Access Compliance Report

Public Rights-of-Way

Intersection ID: 44929	Main Street: TWIN_BROOK_DR	Cross Street: NATHAN_DR	Location: NE
ADA ID: A3BED409E240	Ramp Type: Perp	Initial Pass/Fail: Fail	Overall Compliance: No
Severity Score: 12.5			
Codes/Mitigation Info/Possible Solution		Field Measurements/Component Compliance

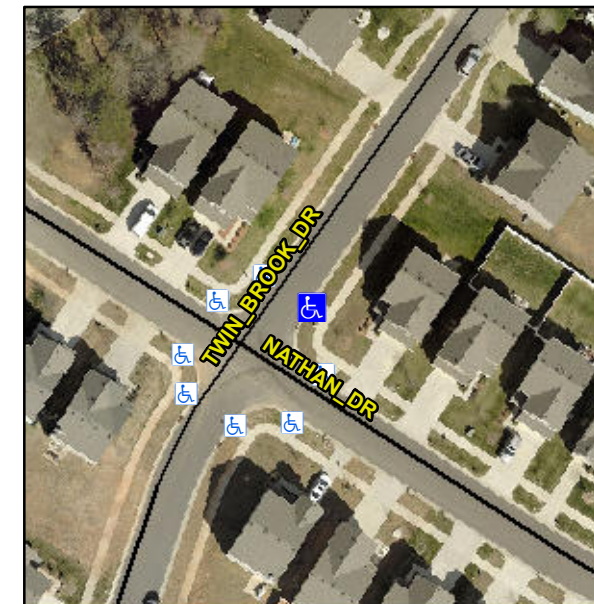
Not Found, R304.2.2

Compliance	Description	Data	Compliance	Description	Data
N/A	Ramp Length (in)	96.5	No	Ramp Slope (%)	10.0
Yes	Ramp Width (in)	59.5	Yes	Ramp XSlope (%)	0.7
N/A	Flare Type LT	N/A	N/A	Flare Type RT	N/A
N/A	Flare Slope LT (%)	N/A	N/A	Flare Slope RT (%)	N/A
N/A	Flare Traversable LT?	N/A	N/A	Flare Traversable RT?	N/A
N/A	Landing Length (in)	N/A	N/A	DWS Provided?	N/A
N/A	Landing Width (in)	N/A	N/A	DWS Contrast?	N/A
N/A	Landing Slope (%)	N/A	N/A	DWS Length (in)	N/A
N/A	Landing X Slope (%)	N/A	N/A	DWS Full Width?	N/A
N/A	Landing Curb? (Y/N)	N/A	N/A	DWS Offset (in)	N/A
N/A	Shared Landing?	N/A			
N/A	Gutter Ponding?	N/A	N/A	Gutter Slope (%)	N/A
N/A	Gutter Lip Ht (in)	N/A	N/A	Gutter X Slope (%)	N/A
N/A	Painted X Walk1?	No	N/A	Painted X Walk2?	N/A
	X Walk 1 Direction	To NW		X Walk 2 Direction	N/A
N/A	X Walk 1 Width (in)	N/A	N/A	X Walk 2 Width (in)	N/A
	X Walk 1 Slope (%)	3.9		X Walk 2 Slope (%)	N/A
	X Walk 1 X Slope (%)	0.7		X Walk 2 X Slope (%)	N/A

Remove & Replace Entire Ramp.
